## Study Plan 22: Sultan River Physical Process Studies Final Technical Report

The objective of *Study Plan 22: Sultan River Physical Process Studies* was to evaluate how current and proposed operations of the Henry M. Jackson Hydroelectric Project affect fluvial processes and channel morphology in the Sultan River, particularly those that affect populations of anadromous salmonids. The ultimate goal is to provide a physical process context for the Sultan River to help guide management choices for aquatic and riparian habitat in ways that benefit aquatic species.

**Figure 2-2 Cross-section comparison at the Kien's Bar Site, XS 1.** Elevation is relative to the Rock BM elevation (200 ft) given in the 1984 GeoEngineers survey.

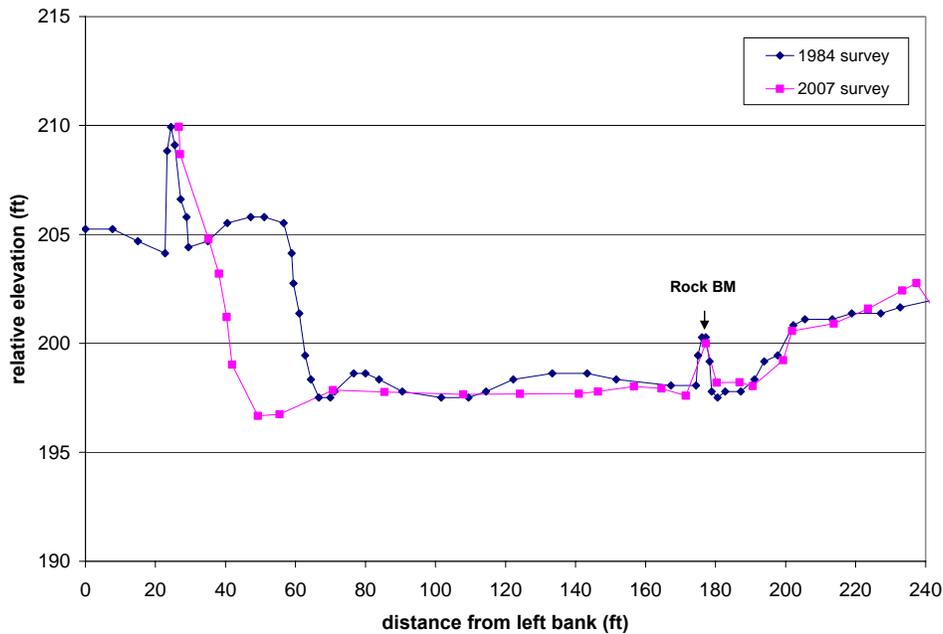
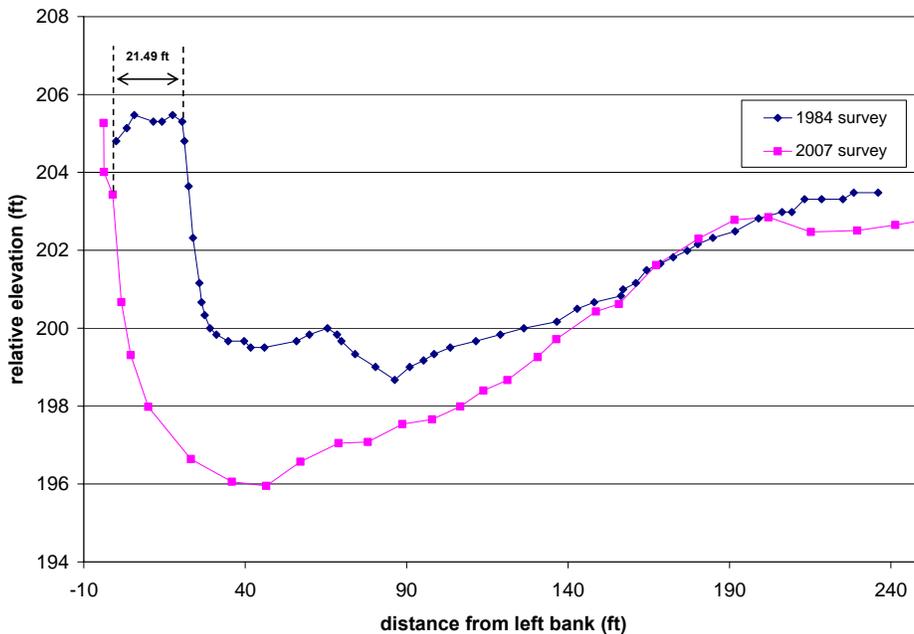
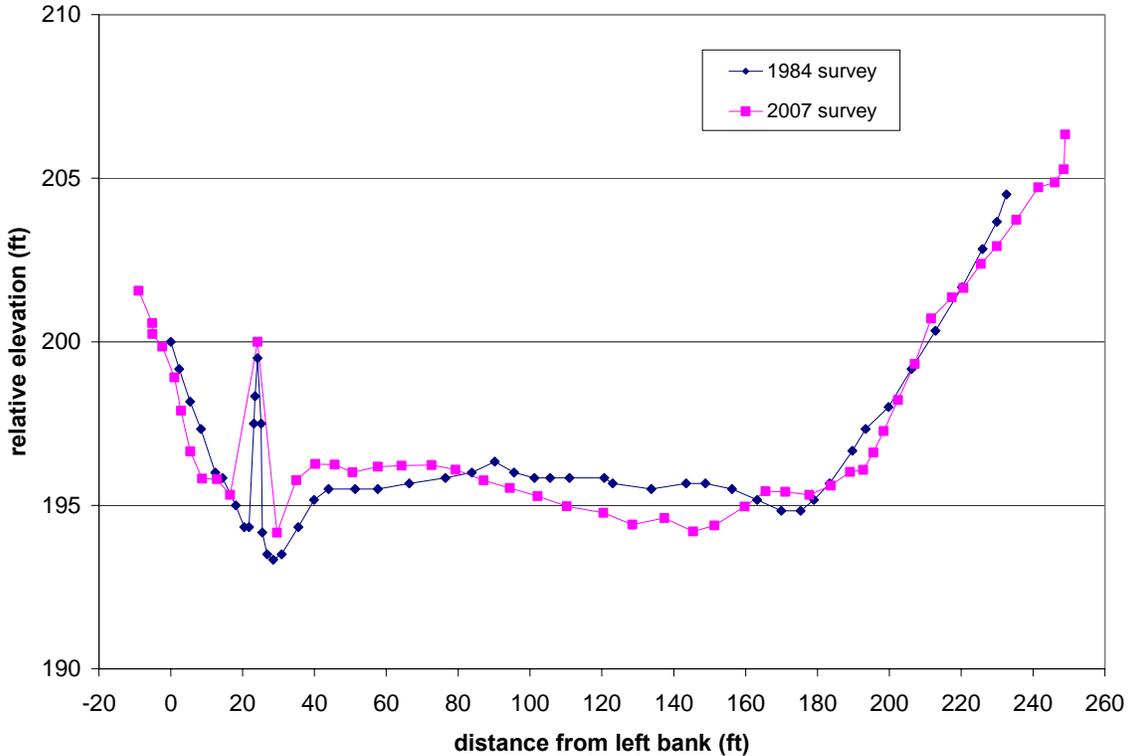
STAKEHOLDER COMMENT	LICENSEE RESPONSE
<p>The channel cross-sections (Figures 2.2 to 2.5) in the lower river show a progressive deepening of the channel from 1984-2007. We also noted during our field review numerous reaches of high, steep banks along this lower river area. The report would benefit from some discussion of whether the channel deepening is a result of vegetative encroachment and stabilization of the riparian gravels (due to a change in the high flow regime) or whether channel deepening may have occurred as a result of levee construction and removal of wood. It appears as though the "base level" of these alluvial reaches of the river are significantly lower than some prior condition.</p>	<p>The limited number of cross sections makes generalizing about incision or deposition throughout PR1 problematic. We agree that cross sections are suggestive of incision, especially coupled with other evidence that you observed; however, we are less certain that the entire extent of PR1 has incised. The most likely reasons for the observed narrowing and possible incision are the altered Stage 2 hydrograph, and the consequent encroachment of the channel, and the removal of LWD.</p>

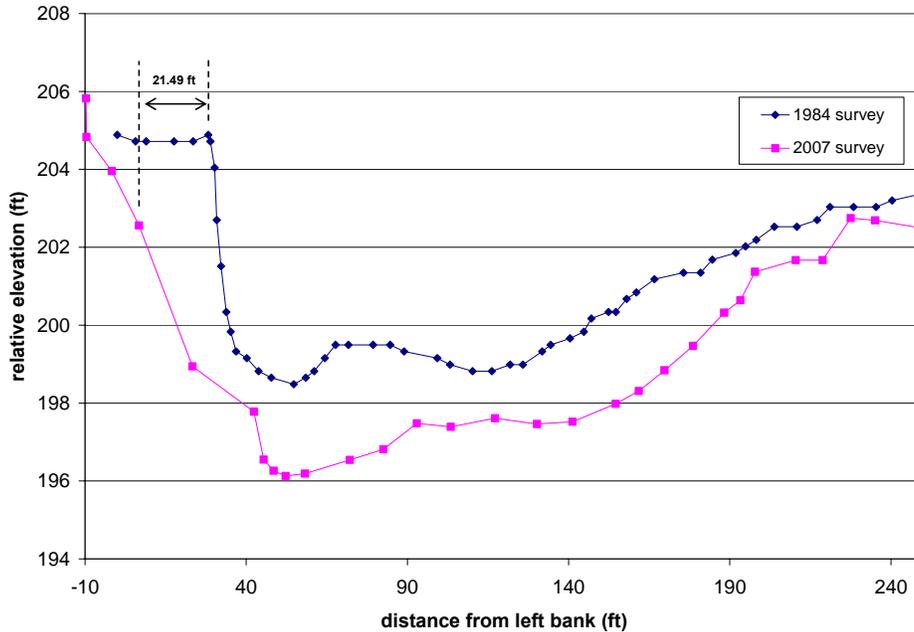
<p><b>Section 2.1, Page 5.</b>            This section’s title, “Sediment Input, Routing and Fate,” could be changed to “Sediment Input, Routing and Deposition.”</p>	<p>Thank you, we made the suggested edit.</p>
<p><b>Section 2.1.3.3.1, Page 20.</b>            Figure 2-3 captions should be changed to read “Note change in Y-axis scale relative to Figure 2-2.”</p>	<p>Thank you, we made the suggested edit.</p>

**Figure 2-6** Cross-section comparison at the Upper Site. Elevation is relative to the BM 1 and BM 2 elevations derived from the 1984 GeoEngineers survey plot.

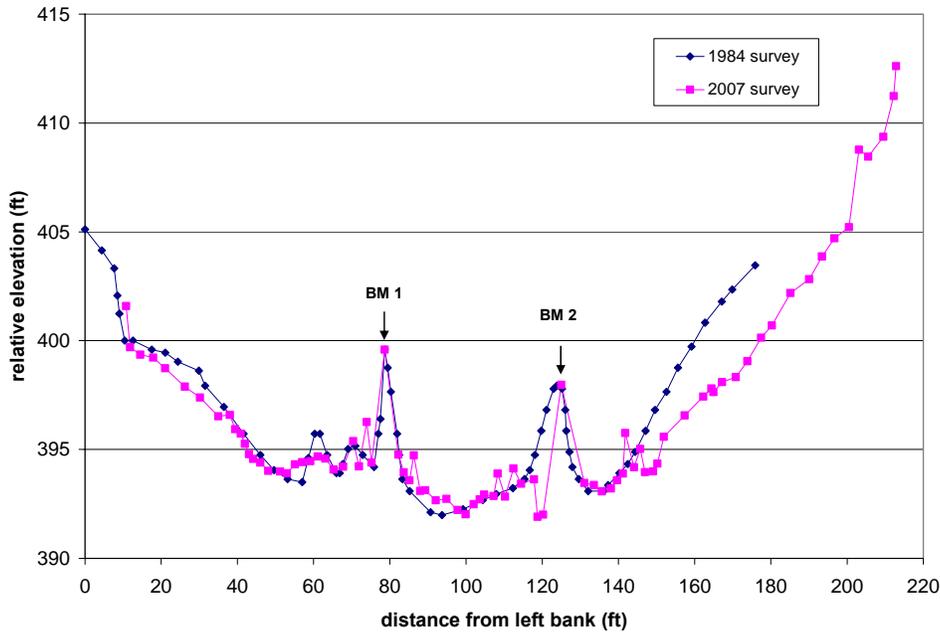
<p>The cross-section at the upper site (Figure 2.6) shows the diversity of channel conditions and off-channel areas normally associated with highly productive fish habitat. Additional cross-sections in this area would be valuable in helping define the geomorphic characteristics and resource values of this reach. We understand RSP 3 (Instream Flow Study) will provide additional assessment of fish habitat conditions above the diversion dam and we look forward to reviewing those results.</p>	<p>Comment noted.</p>
<p>As per our comments on Study Plan 18, we are still not comfortable with the definition of "side channels" used for these reports. The requirement for discernable flow connected by an upstream inlet and downstream outlet does not represent the range of side channel characteristics we need for fish habitat assessments. The islands and meander bars on the Sultan River contain numerous overflow channels, of variable depths and lengths, that carry (or used to carry) high flows and have important instream functions. We still do not have an adequate characterization of the flow paths for high flows in this river environment. At some point, we need to compare a range of specific high flows and where those flows go to understand the "shifting habitat mosaic" so important to fish productivity in the Sultan River.</p>	<p>Quantitative assessments of fish habitat are currently being performed in RSP 3 at 18 transect locations in three side channels of Reach 1 of the Sultan River. Depths, velocities, substrate characteristics, and cover habitat were measured at 20 plus vertical locations across each transect under flow conditions ranging from low to high. The physical data collected in this study will be used to assess fish habitat for various species/life stages in side channels located in Reach 1. Time series analyses of fish habitat will be conducted, and compared with periodicities of the various species/life stages to assess fish habitat on a seasonal basis during wet, dry, and average years under pre- and post-project conditions.</p>

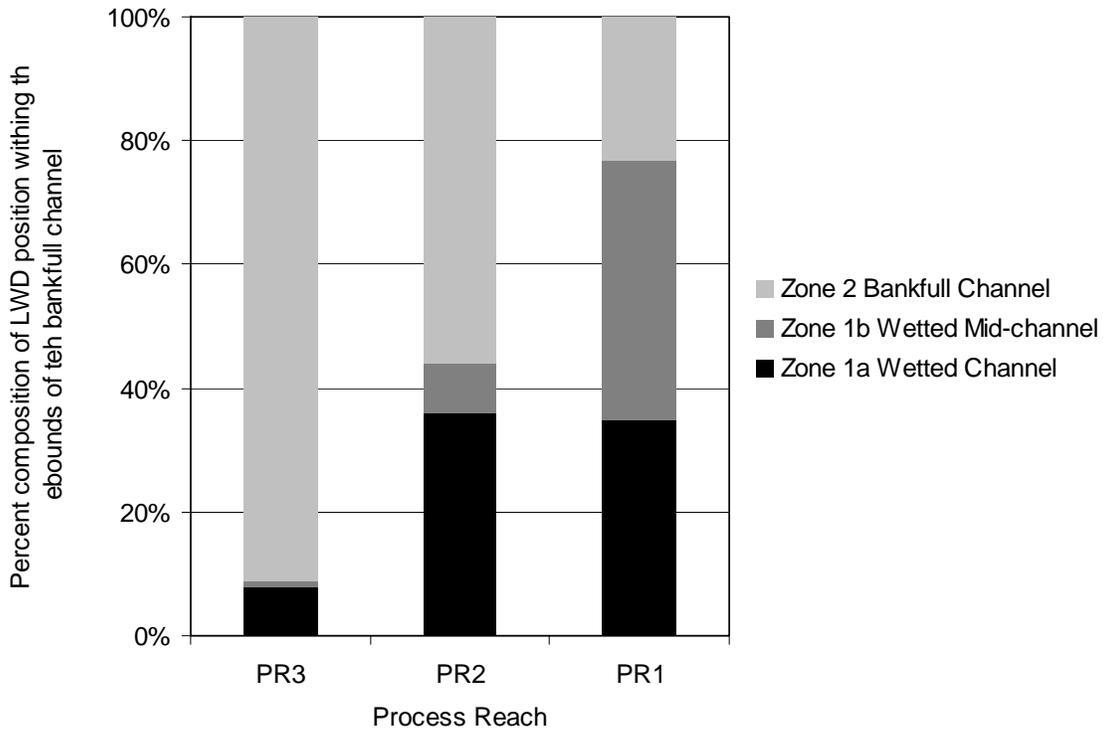
STAKEHOLDER COMMENT	LICENSEE RESPONSE
	marked pattern of increase or decrease in median bed-surface particle size.
<p><b>Section 2.3.4, Page 40.</b>                      We would prefer that Figure 2-18 be reworked to represent process reach boundaries as this is how the data are reported throughout the entire report. It is particularly appropriate since the discussion of LWD results exclusively refers to process reaches.</p>	<p>This figure has been updated to reflect Process Reach boundaries.</p>
<p><b>Section 3.0, Page 41.</b>                      The Geomorphic Synthesis section briefly mentions the role of peak floods but primarily directs the reader to the IHA/RVA study for more detailed discussions of changes in the hydrologic system. Since the majority of geomorphologic changes are tenuously linked to flow, this forcing function should be scrutinized in closer detail in the document. Specifically, we would like the following questions considered:</p> <p>Was the natural hydrograph pre-stage 2 vs. post-stage 2 considered? The natural hydrograph (Gold Bar gauge used to approximate area peak floods) shows many more peak floods between 1957-2008 than prior to 1957. Was there any photographic evidence of what peak floods did to PR1 complexity in the photo record?</p> <p>What size flood is needed to inundate some of the vegetated bars? What size would be needed for incipient motion on the bars (to mobilize that class of sediment)?</p>	<p>Our sediment transport modeling specifically considered daily discharge from Stage 1 and Stage 2 periods. Our sediment transport model (EASI) uses daily discharge rather than peak discharge, because of the availability of data and the importance of duration in sediment-transport calculations. We made no analysis of peak floods between Stage 1 and Stage 2, because this was beyond the scope of this study. For similar reasons we did not use the natural hydrograph from prior to Stage 1, but rather compared Stage 1 and Stage 2 hydrographs in our modeling.</p> <p>By extension, our discussion of riparian vegetation encroachment is couched in differences in the magnitude of sustained floods between Stage 1 and Stage 2. Qualitative review of the 1997 aerial photography suggests that some scour occurred during the large floods of 1996, but we made no quantitative analyses. There is new aerial photography from 2007, which may show some evidence of scouring from the water year 2007 flooding, but this imagery was not ready at the time of our work.</p> <p>A hydraulic routing model, such as HEC-RAS, could possibly estimate the discharge required to inundate gravel bars throughout the river, but this would not provide direct evidence of sediment transport. The tracer rock study, which is in progress, may give some empirical insight into the instantaneous discharge required initiate sediment transport (i.e. incipient motion). During 2007, none of the controlled flow releases (maximum discharge of 880 cfs) transported any of the tracer rocks. In 2008, there are no scheduled flow releases and movement of the tracer rocks is dependant on any uncontrolled</p>
